# ATTACHMENT C

City's presentation to the SAPCB and Virginia DEQ, November 19,  
2007

**State Air Pollution Control Board  
&  
Department of Environmental Quality**

By  
**City of Alexandria**

## Trona Does not Reduce PM Emissions

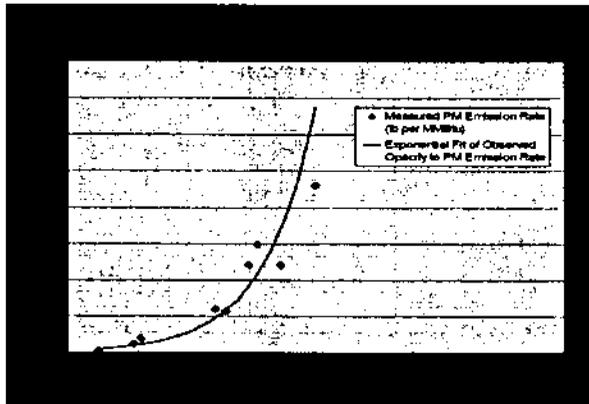
Mirant opacity data showed increase in opacity with trona injection, and potentially PM<sub>2.5</sub> emissions (~20,000 data points for each boiler)

Boiler #3 showed the least negative impacts of trona on opacity. However, it was the only boiler used for comparing scenarios with and without trona in 2006 stack testing
